<b>Docket Number:</b>	21-AFC-02
<b>Project Title:</b>	Willow Rock Energy Storage Center
<b>TN #:</b>	259220
<b>Document Title:</b>	Willow Rock Data Request Set 2 Response
<b>Description:</b>	N/A
<b>Filer:</b>	Kathryn Stevens
<b>Organization:</b>	WSP USA Inc.
<b>Submitter Role:</b>	Applicant Consultant
<b>Submission Date:</b>	9/19/2024 11:11:49 AM
<b>Docketed Date:</b>	9/19/2024

**Willow Rock Energy Storage Center (21-AFC-02)**  
*Data Request Response Set 2*

**Figure DR31-1: Arrangement of Fuels and Lubes within the Connex during Construction**

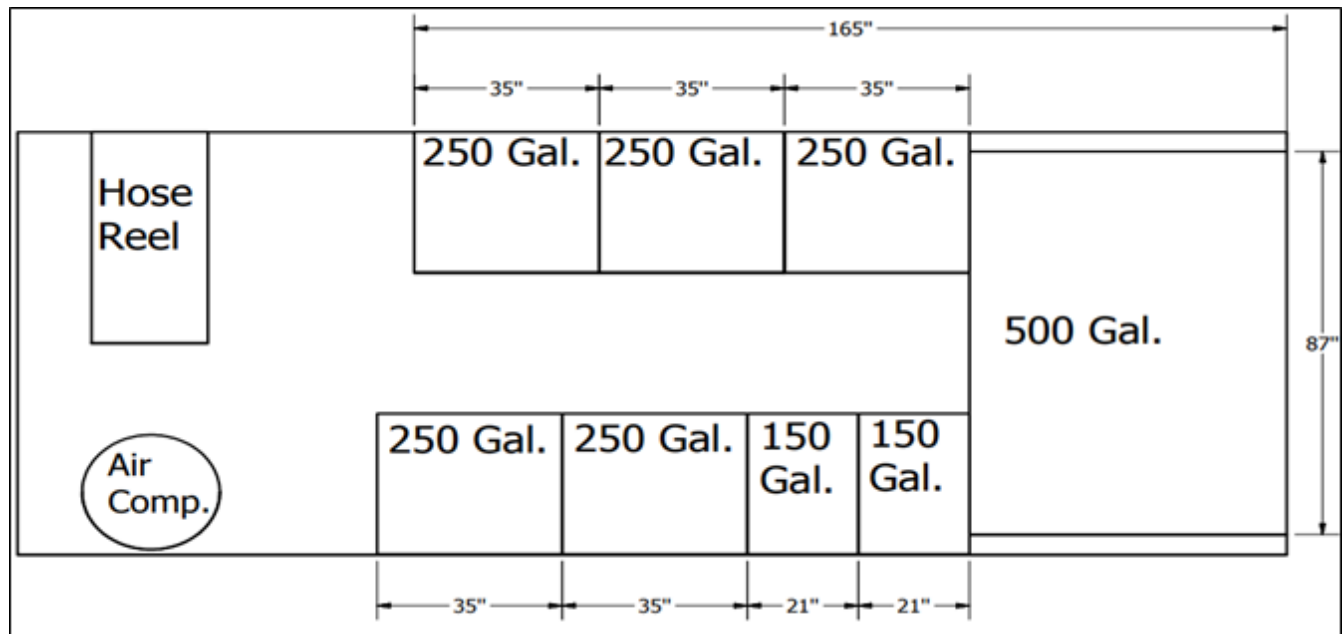
**DR31:** *Provide a discussion of anticipated uses, storage volumes, types, and locations for hazardous materials used during project construction. Provide a table similar to Table 5.5-1 through 5.5-3 as an example.*

Passivating and chemical cleaners and lubricating oil will be used on various mechanical equipment during construction. Hydraulic fluid, motor oil, diesel fuel, and gasoline will also be used onsite for motorized equipment and emergency generator use. **Table DR31-1** presents a list of oils and fuels.

There are no feasible alternatives to vehicle fuels and oils for operating construction equipment. The arrangement of fuels and lubes within the connex during construction is presented in **Figure DR31-1**.

## **WRESC Plot Plan**

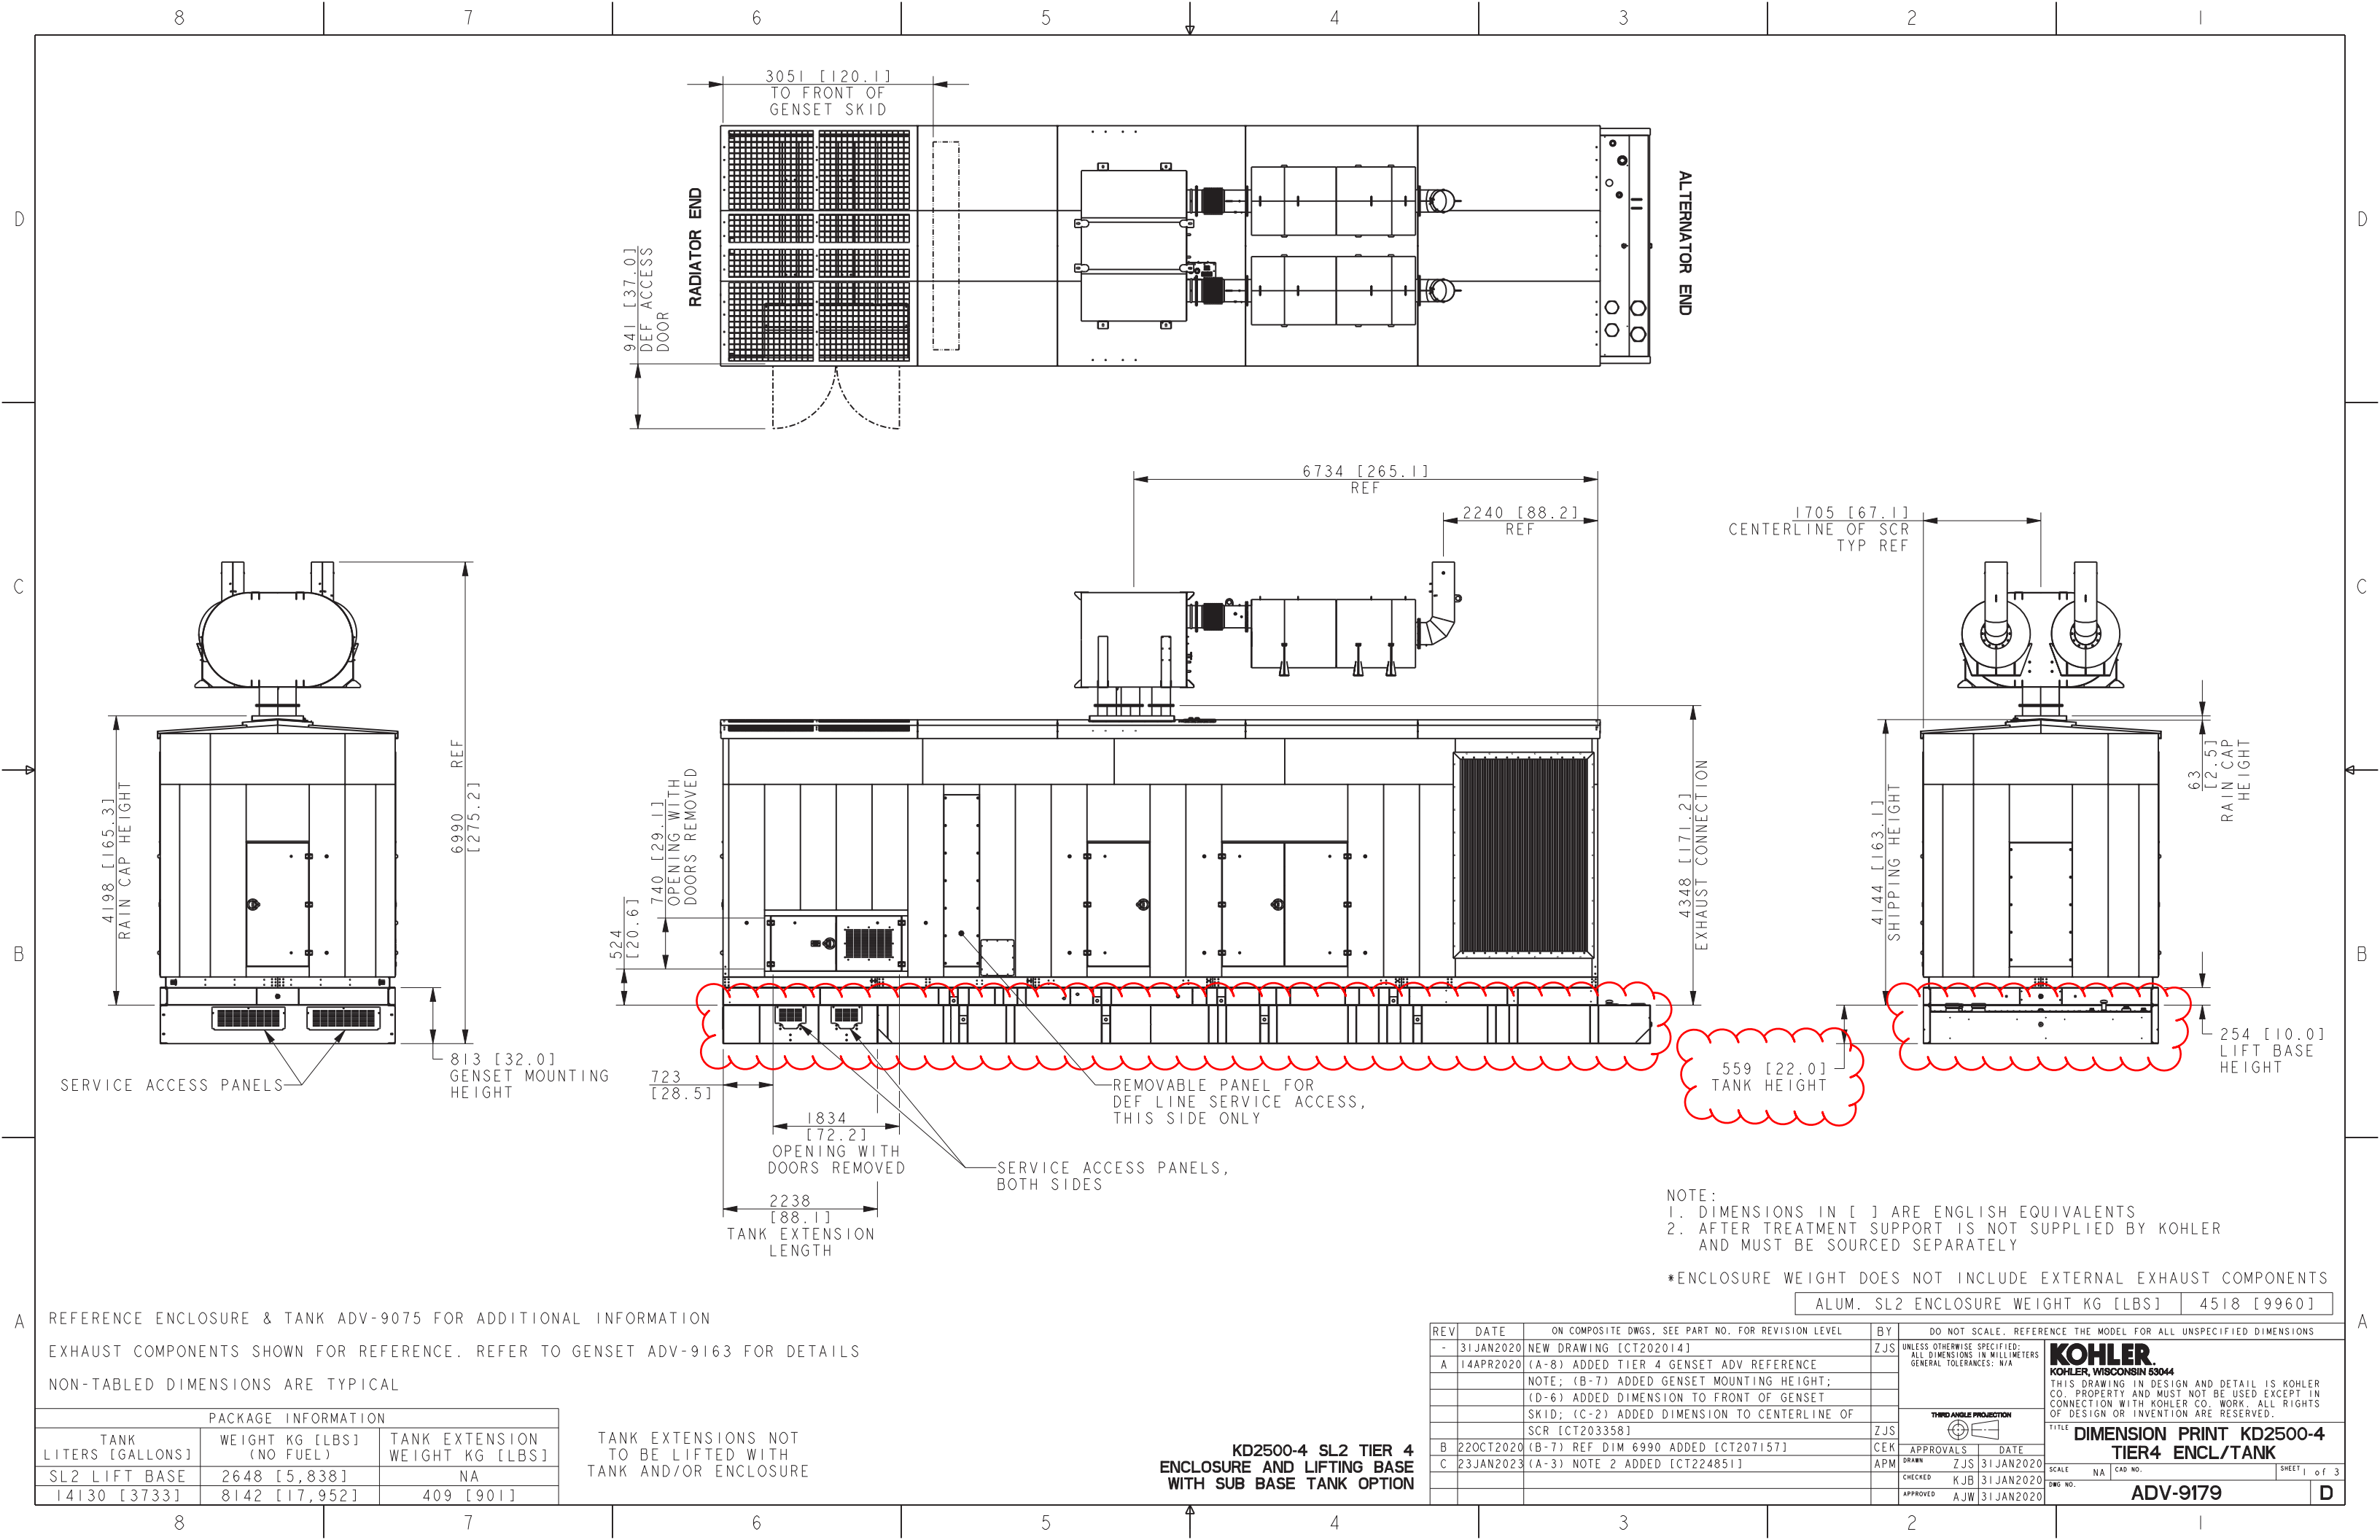
**DR26:** Please clarify volume, location, and type of storage of diesel fuel for the four generators to be used during project operation.

**Response:** As noted in Table 5.5-4 of the SAFC, a dual-walled steel, integrated tank installed at the WRESC will not be accessible to the public and will have a tank capacity of 600 gallons to 12,000 gallons or more (Section 5.5.4.2.2). The location for the three emergency diesel generators (EDG) is shown on the plot plan (**Attachment DR26-1**). Each of the three engines has a 3,733-gallon subbase diesel fuel tank. See the EDG enclosure outline drawing (**Attachment DR26-2**) with the tank clouded. The location for the diesel fire pump is shown on the plot plan (**Attachment DR26-1**). Within the fire pump enclosure is a 600-gallon diesel fuel tank.

**Proposed Locations of  
Transmission Line Poles and  
Undergrounding Maps  
(submitted via Kiteworks)**

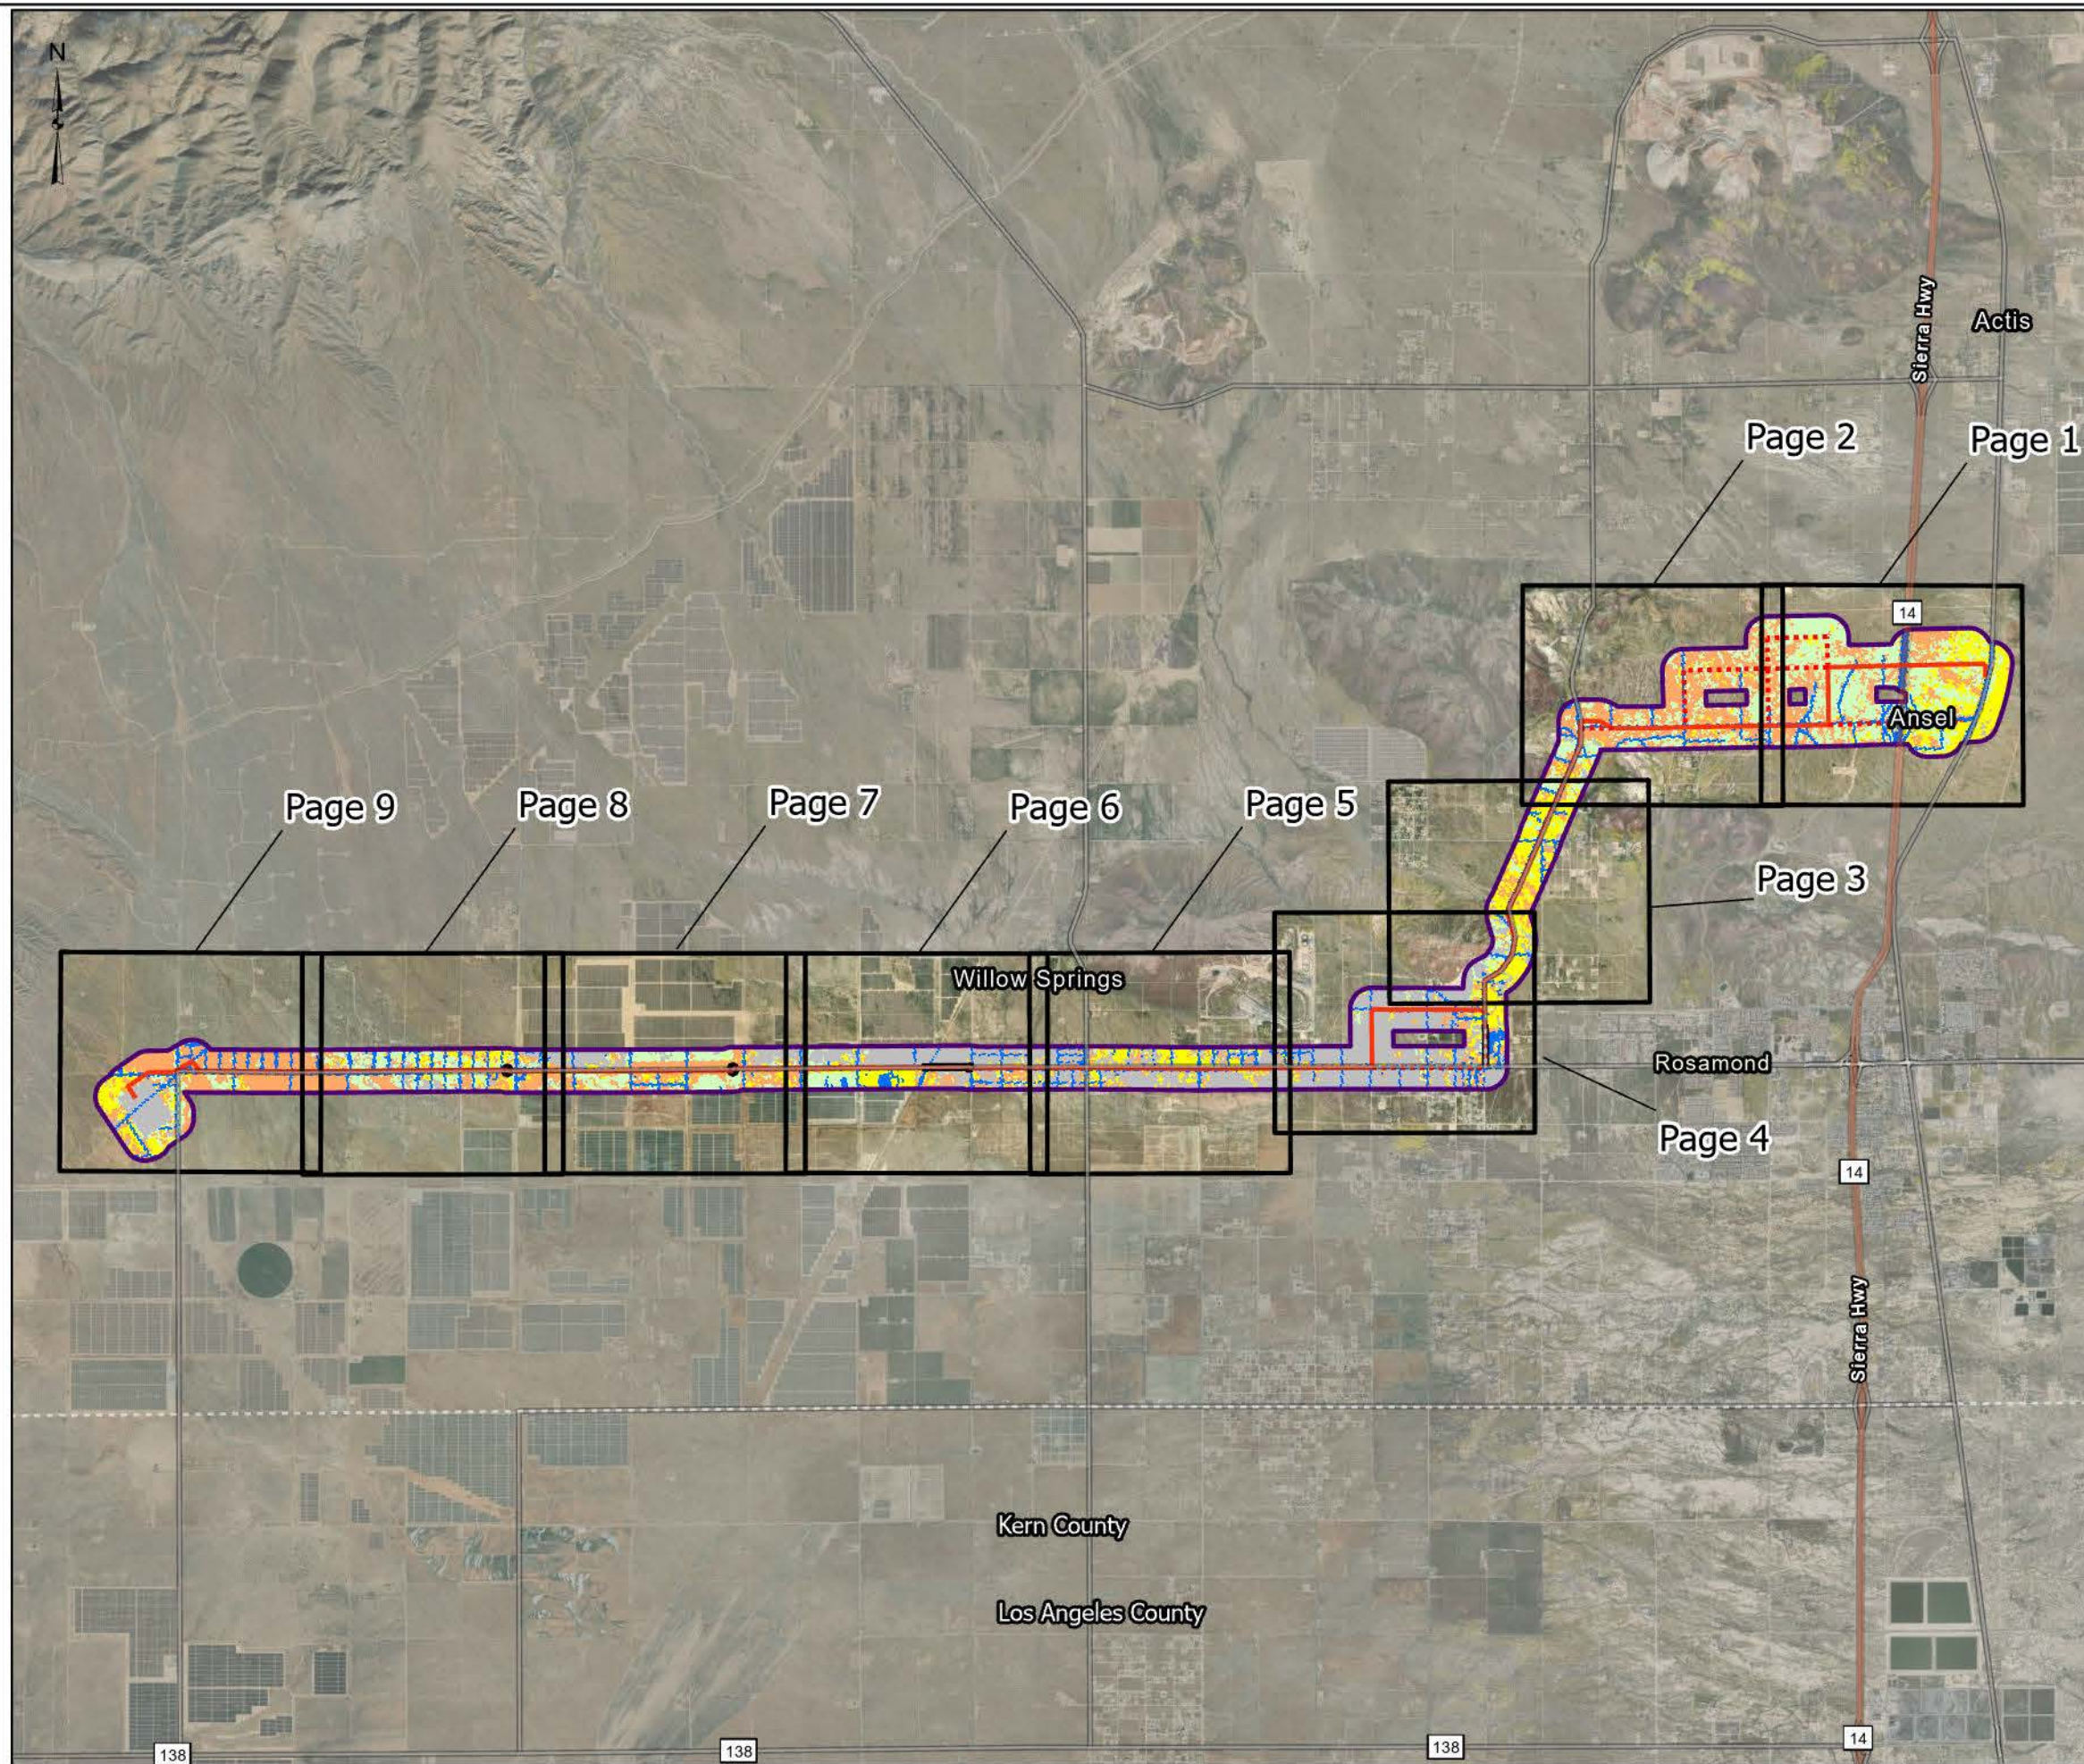
**DR35:** *Provide locations of anticipated ground disturbance along the transmission line, including anticipated surface areas and depths.*

**Response:** Attachment DR35-1 presents a map that shows the proposed location of transmission line poles from between WRESC and the SCE Whirlwind Substation. Attachment DR35-1 also shows the location of undergrounding associated with the gen-tie line. Due to its file size, Attachment DR35-1 was submitted through Kiteworks. As the Front-End Engineering Design (FEED) and stakeholder engagement with Kern County progresses, the final location of transmission line poles will be updated and provided to the CEC.
